BRONX COMMUNITY BOARD 8

AMENDED MEETING NOTICE **ENVIRONMENT & SANITATION COMMITTEE**

Bronx Community Board 8 Comments on the NYNJHATS Tier 1 Feasibility Study, for Submission to the NYNJHATS Project of the USACE

Figure 3 Friends of Van Cortlandt Park power point

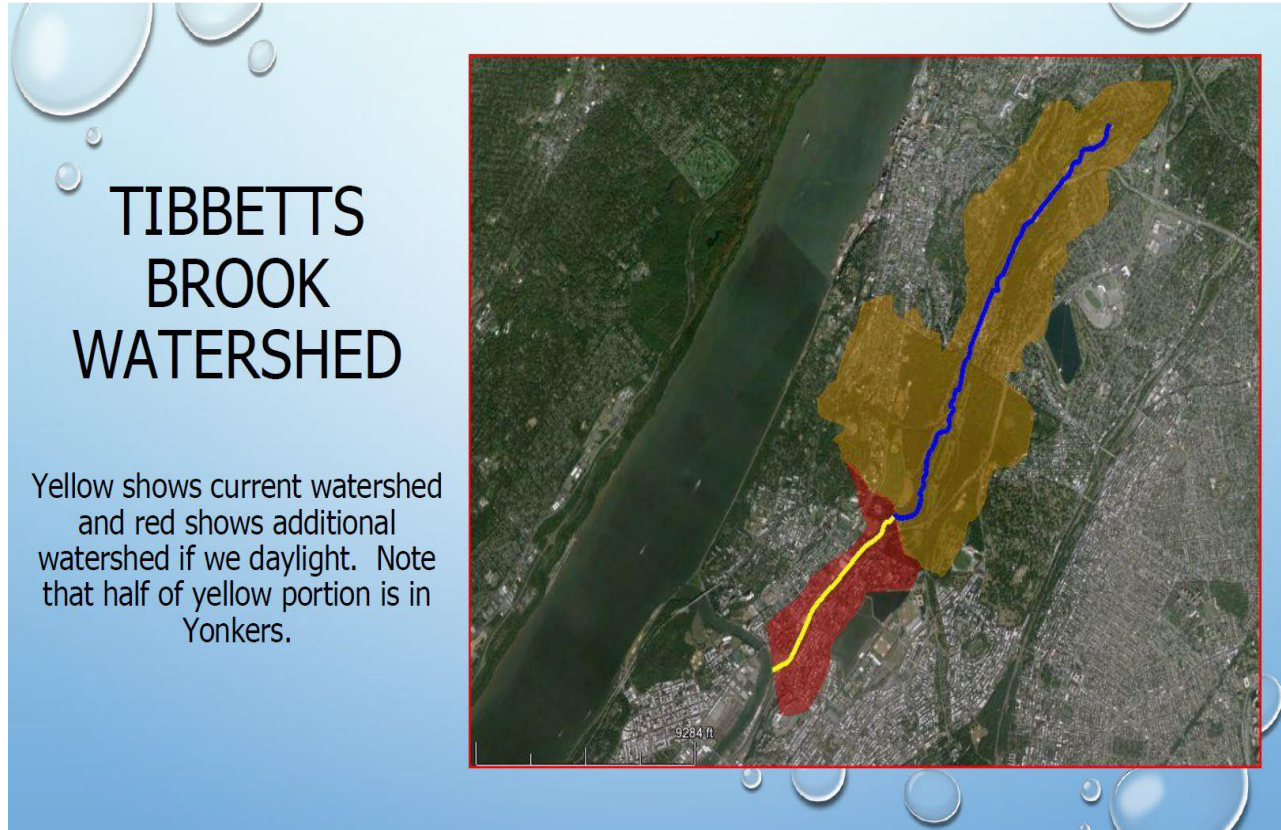
We are concerned that the mitigations discussed in the current version of the study will have a direct impact on Van Cortlandt Lake once the daylighting project is completed due to blocking outfalls and increasing storm surge by directing more water north.

Figure 3 Friends of Van Cortlandt Park power point

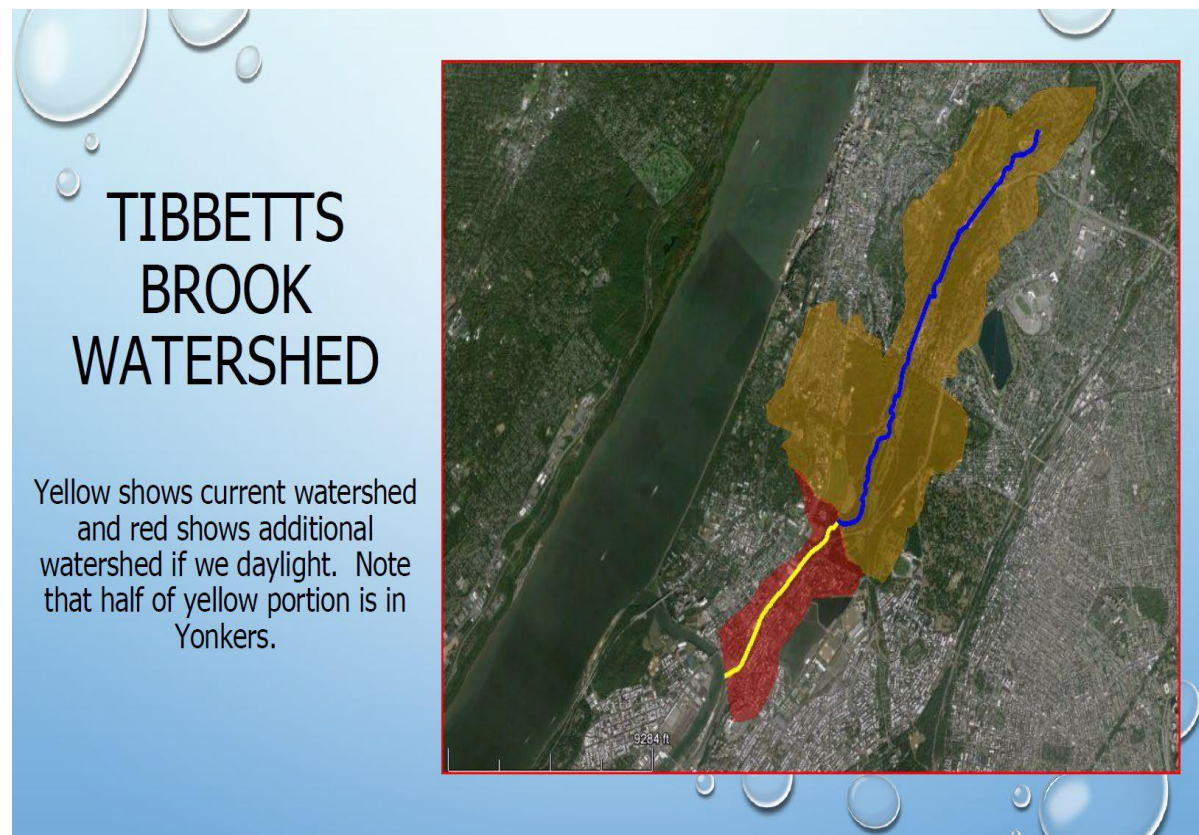
We are concerned that the mitigations discussed in the current version of the study will have a direct impact on Van Cortlandt Lake once the daylighting project is completed due to blocking outfalls and increasing storm surge by directing more water north.
